# RULES FOR THE SURVEY AND CONSTRUCTION OF STEEL SHIPS

Part C

#### 2016 AMENDMENT NO.2

Rule No.82 27th December 2016

Fig. C32.9.8-1 Effective Shear Area in Way of Web Openings

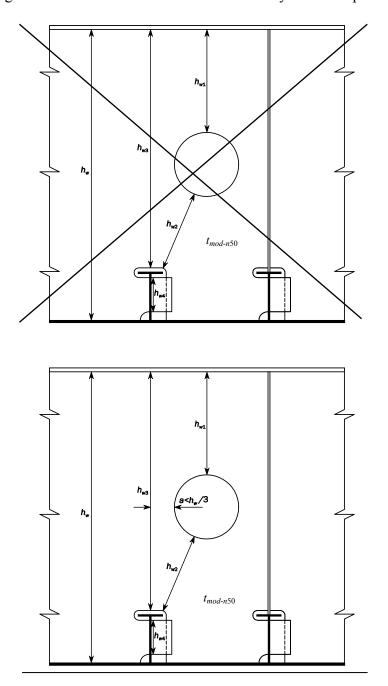
- 1 In the application of **32.9.8**, **Part C of the Rules**, when fine mesh is used rather than the standard mesh given in **C32.9.7-3**, the mean stress corresponding to the standard mesh may be used.
- 2 The "deemed appropriate by the Society" specified in 32.9.8-2, Part C of the Rules means calculating the shear stress and the stress in the spanwise direction of girder in consideration of the effective shear area of the web. The effective shear area of the web is to be taken as the web area deducting the area lost due to openings in accordance with the following (1) and (2):
- (1) When both sides of the web are plate members, the equivalent stress  $\sigma_{eq\_coi}$  is to be calculated with the shear stress modified in accordance with following formula:

$A_{shr-n50}$ : Effective net shear area of web  $(mm^2)$  taken as the web area deducting the area lost due to openings calculated with an effective web height  $h_{eff}(mm)$ .  $h_{eff}$ , which is to be taken as the lesser of the following, where the third formula is only taken into account for an opening located at a distance less than  $h_w/3$  from the cross-section considered.  $\doteqdot$

$h_w$ : Web height of primary supporting member (*mm*).  $h_{w1}$ ,  $h_{w2}$ ,  $h_{w3}$ ,  $h_{w4}$ : Dimensions shown in **Fig. C32.9.8-1**.

Fig. C32.9.8-1 has been amended as follows.

Fig.C32.13.4-1 Other Weld Areas

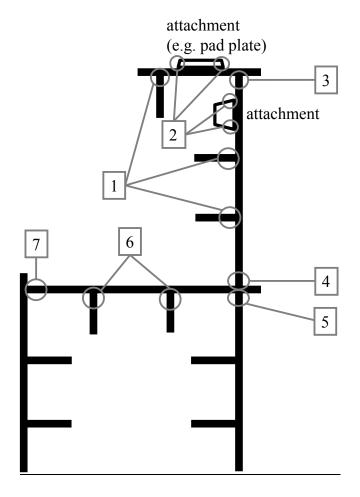
### 1 "Other weld areas" in 32.13.4-3(3), Part C of the Rules includes the following (refer to Fig.C32.13.4-1):

- (1) Fillet welds where hatch side coaming plating, including top plating, meets longitudinals;
- (2) Fillet welds where hatch side coaming plating, including top plating and longitudinals, meets attachments. (e.g., Fillet welds where hatch side top plating meets hatch cover pad plating.);

- (3) Fillet welds where hatch side coaming top plating meets hatch side coaming plating;
- (4) Fillet welds where hatch side coaming plating meets upper deck plating;

- (5) Fillet welds where upper deck plating meets inner hull/bulkheads;
- (6) Fillet welds where upper deck plating meets longitudinals; and
- (7) Fillet welds where sheer strakes meet upper deck plating.

Fig. C32.13.4-1 has been added as follows.
